Chilmark Rejects Squibnocket Plan

How does this conform to town vote for a “low causeway”?

Will of the people

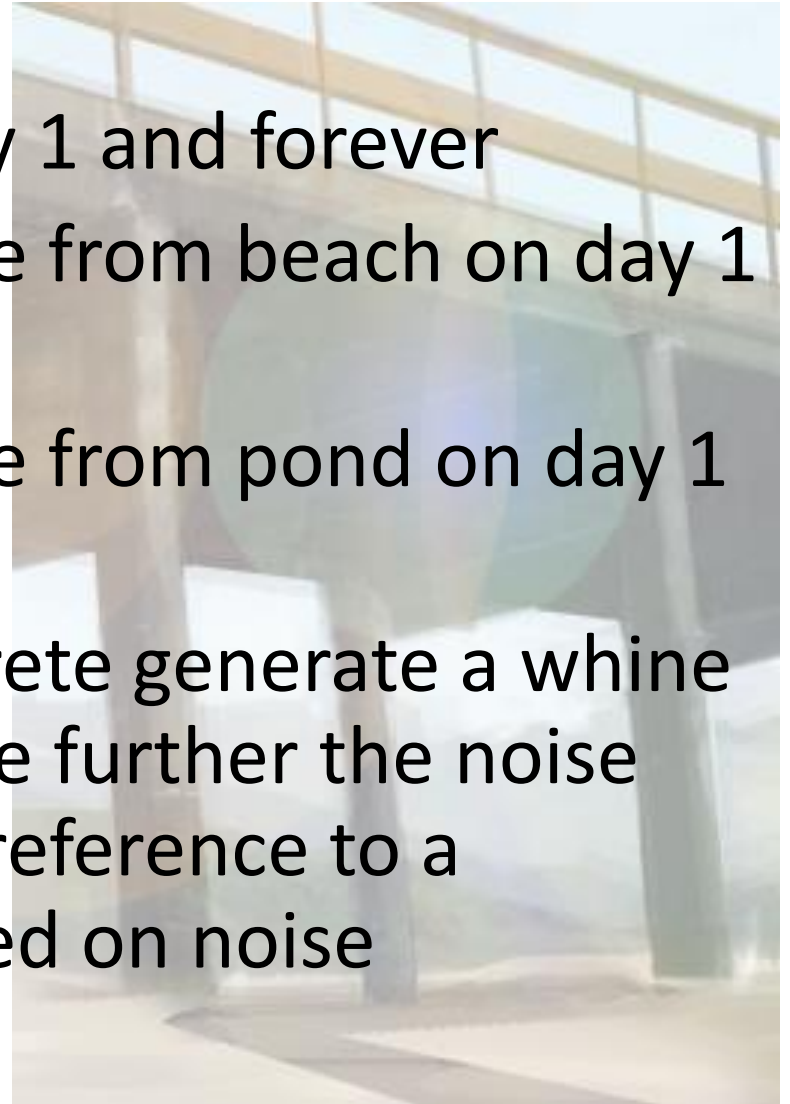
How does this conform to zoning in Squibnocket Pond Overlay District?

1. Development should be unobtrusive and subordinate to existing natural features and vegetation.

2. New structures shall not be built on ridges or hilltops, and intrusion into the skyline as viewed from public places shall be minimized.

*The causeway isn't just a structure, it would be the largest structure in the SPOD

Summary

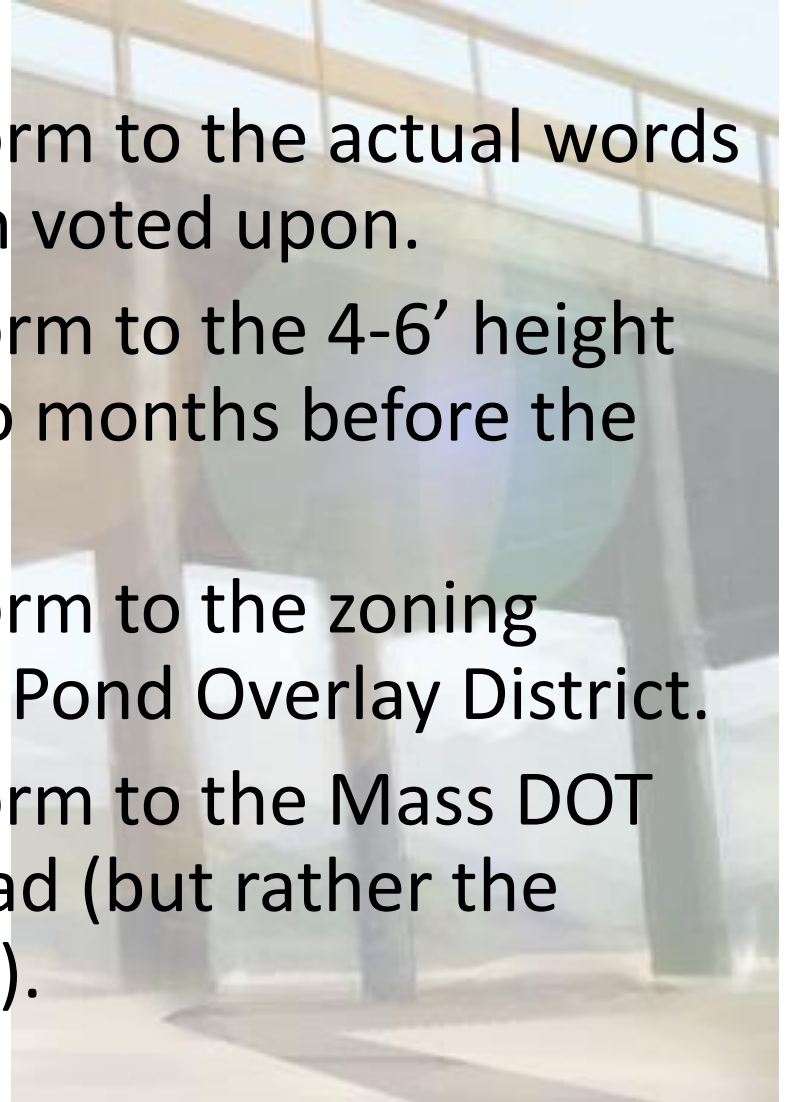
- This design does not conform to the actual words in the article that the town voted upon.
- This design does not conform to the 4-6' height Jim Malkin announced two months before the town vote.
- This design does not conform to the zoning bylaws of the Squibnocket Pond Overlay District.
- This design does not conform to the Mass DOT standards for a country road (but rather the standards for an interstate).
